**Subject:** re: 1/5/22 Public Hearing on Mixed-Use Development Project at 601-649 Escuela Avenue and 1873 Latham Street

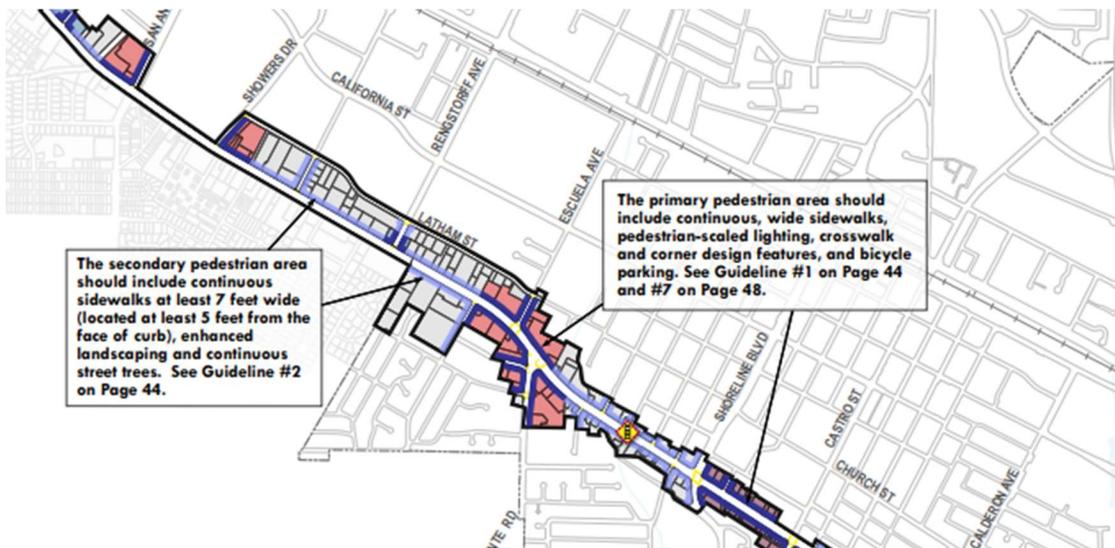
However, it's not clear that the proposed sidewalks -on a route to school- adhere to the El Camino Precise Plan streetscape guidelines.

Please ensure that the sidewalks have the required widths and buffer from the street as well as pedestrian-scaled lighting (a key feature for safety, especially that close to two elementary schools).

According to the El Camino Precise Plan adopted in 2019, the proposed project is designated as a primary pedestrian area (see map snippet from page 45 of the El Camino Precise Plan)
